**Addendum No. 2
January 20, 2023**

Project: Baltic High School Addition
Baltic, South Dakota
Arch Project No. 2957

Architect: Architecture Incorporated

SECOND FLOOR PLAN - AREA F

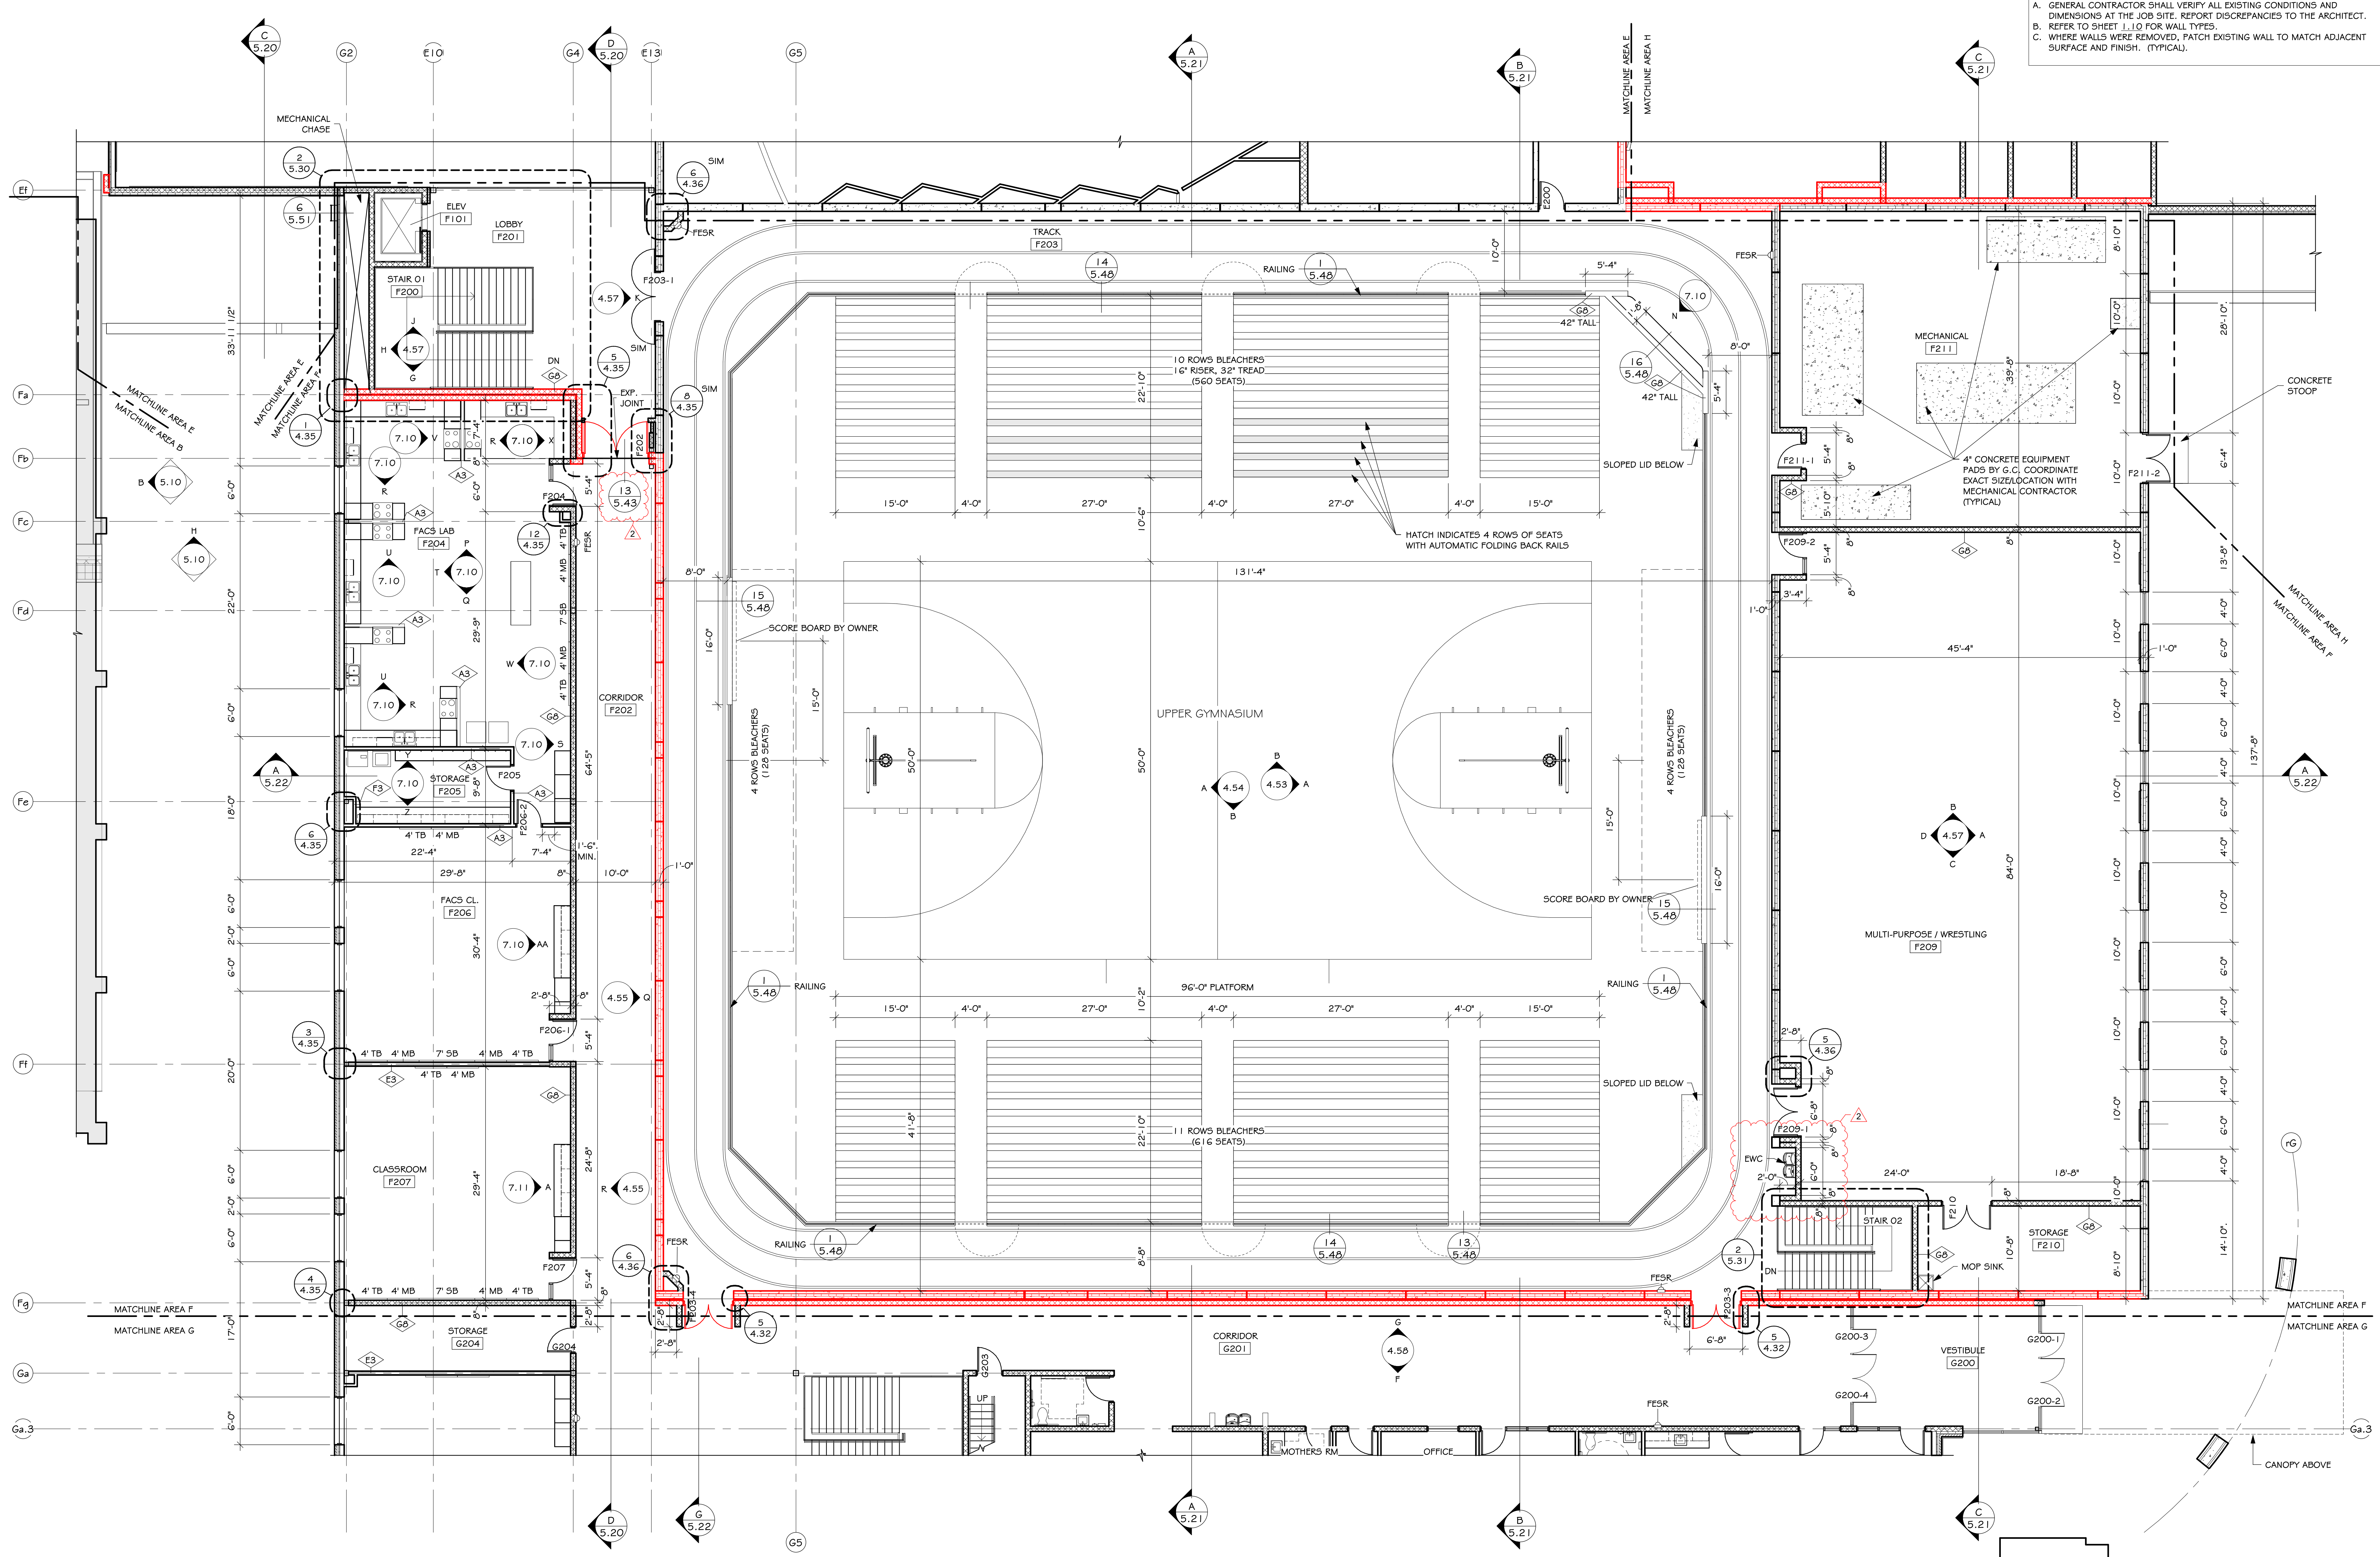
- a) Provide 12” x 16” (solid) precast columns on each side of the electrical water cooler alcove as indicated per *revised* Sheet 4.10-2F (attached to the end of this addendum). Reference structural drawings for additional information.
 - i) Provide additional CMU wall at each side of electrical water cooler alcove.
- b) Add new SECTION DETAIL TAG 13/5.43 along Grid Fb, as indicated on *revised* Sheet 4.10-2F, dated 1-20-23, attached to the end of this addendum.

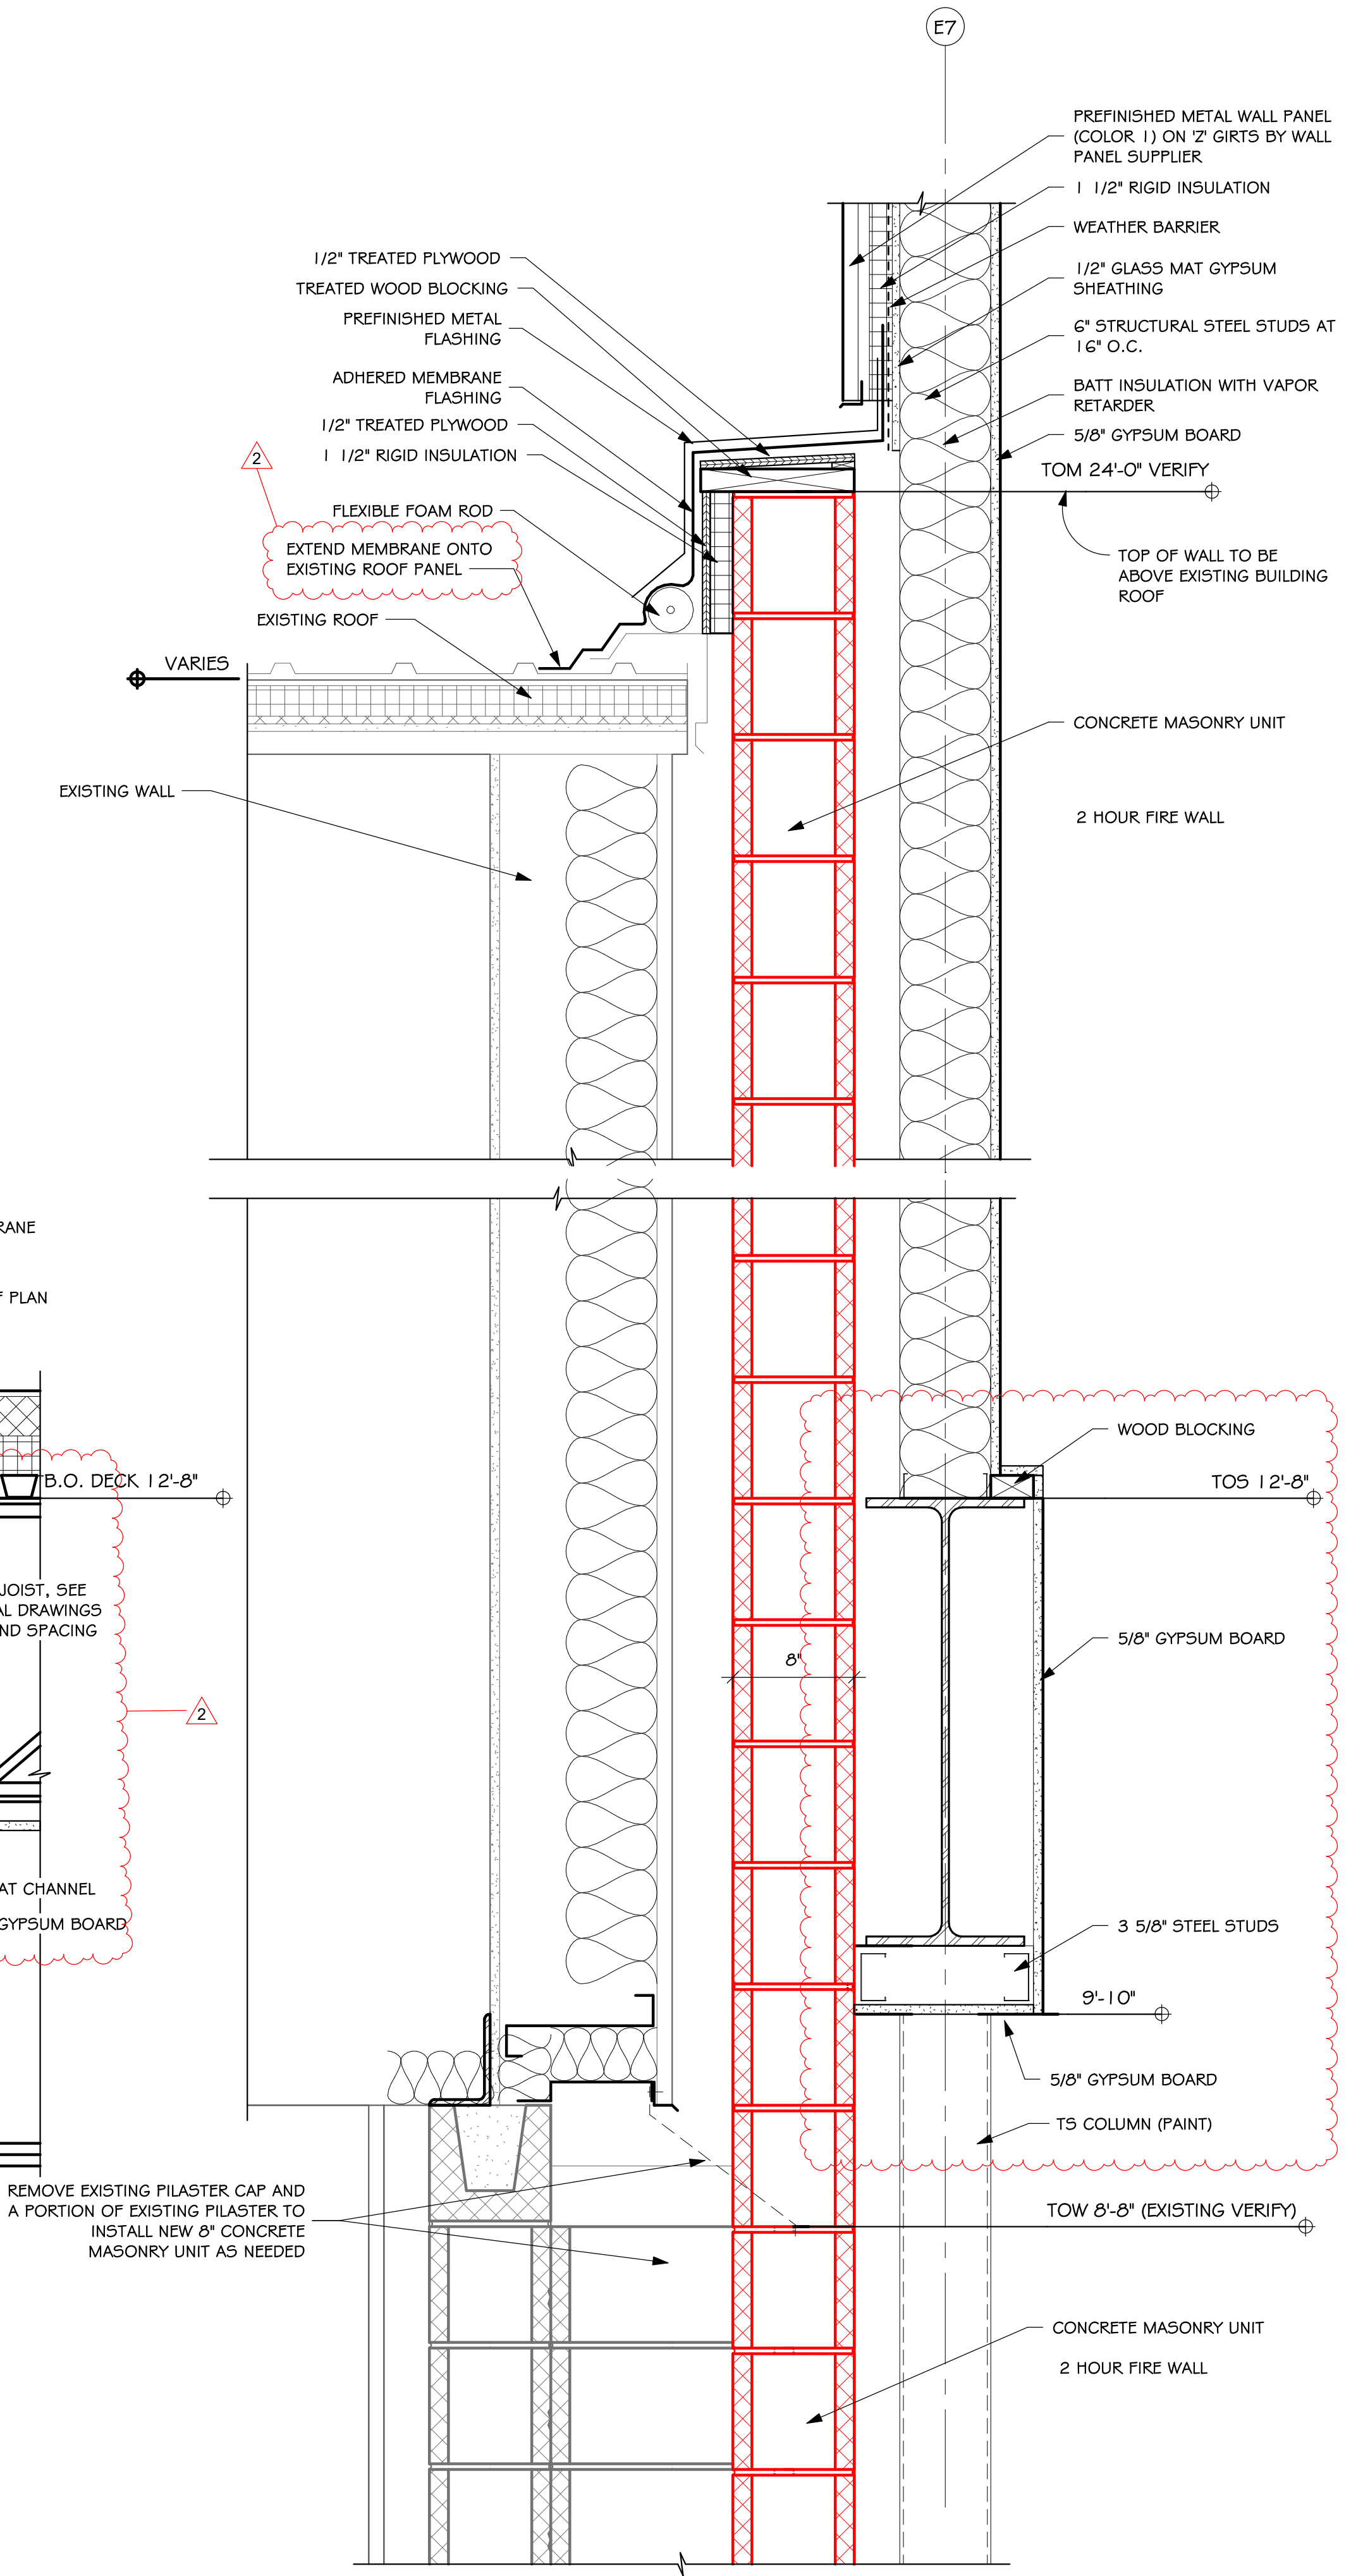
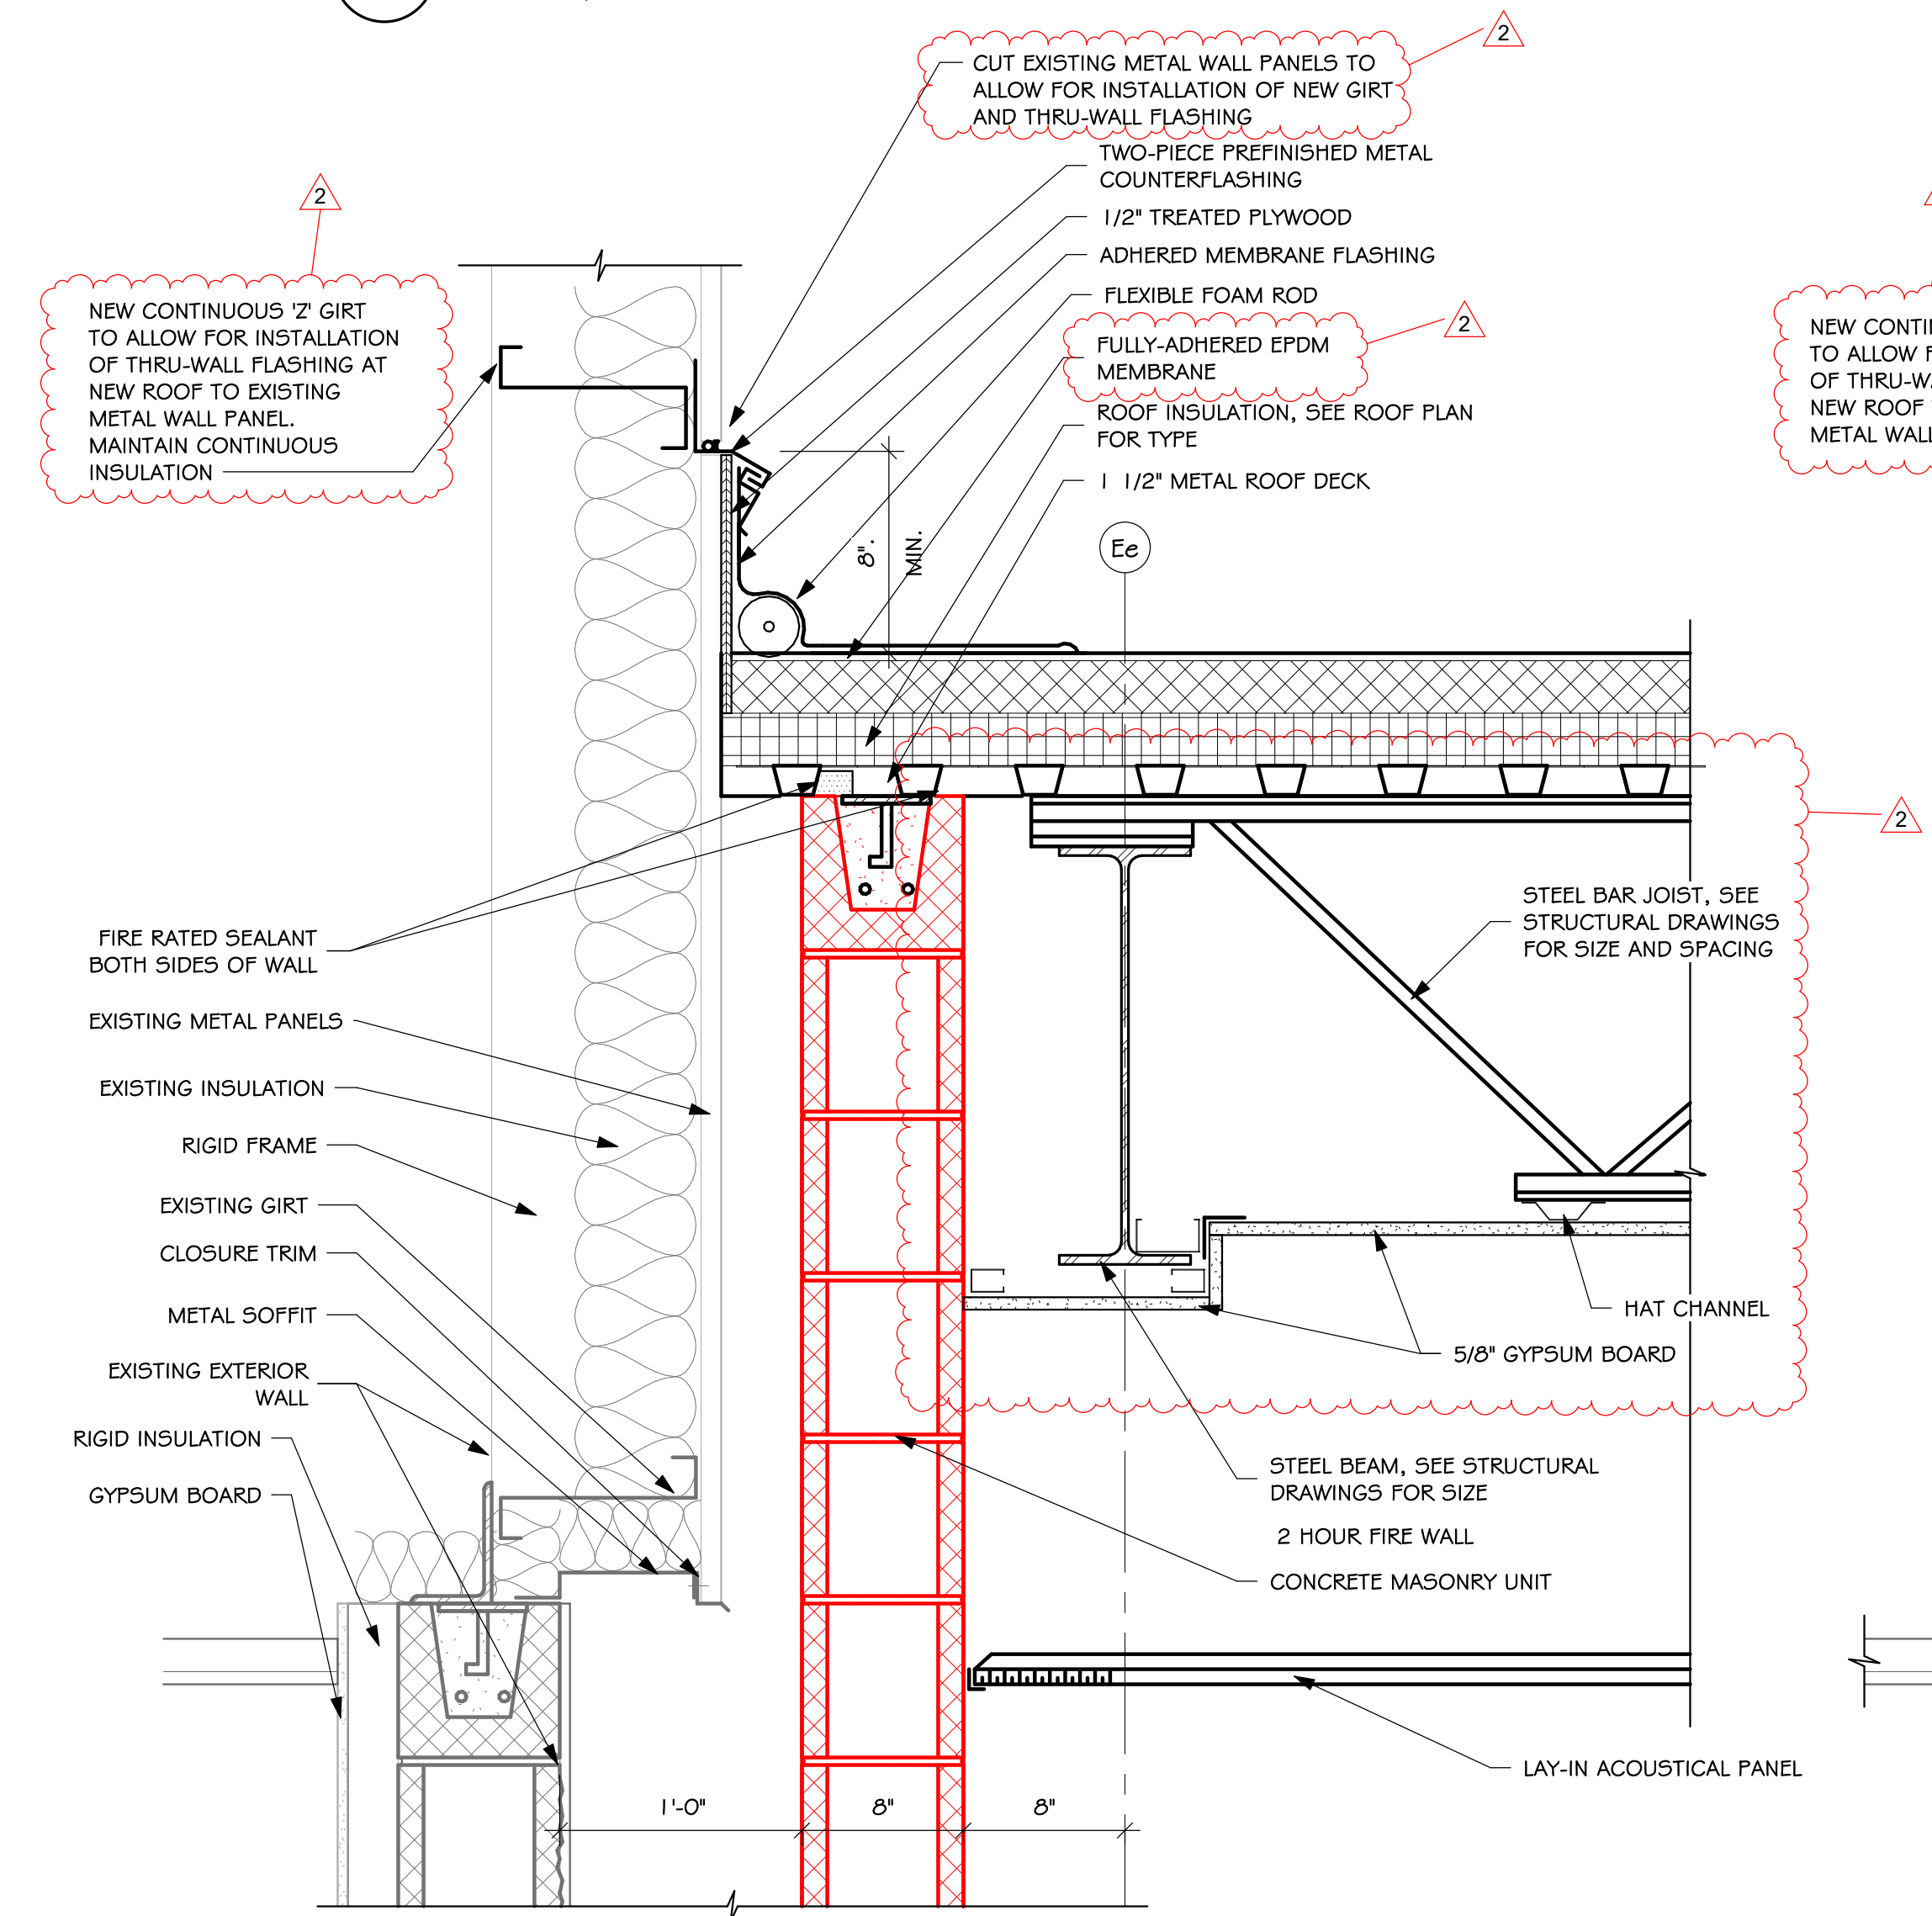
- a) Reference *revised* Sheet 5.40 (attached to the end of this addendum) for revised details 1, 2, 3 & 4/5.40.
 - i) Cut existing metal wall panels to allow for installation of thru-wall flashing and new ‘Z’ girt. ‘Z’ girt shall be installed continuous between existing metal building columns.
 - ii) Install 5/8” gypsum board on the underside of the steel bar joists & beams that occur from grid E1 to E7 and grids Ed and Ee.
 - (1) Along grid Ee, return gypsum board vertically to roof deck. Reference revised detail 3/5.42 on sheet 5.42 (attached).
 - (2) General: 5/8” gypsum board shall be required along the 2-hour fire wall between existing and new construction as indicated.
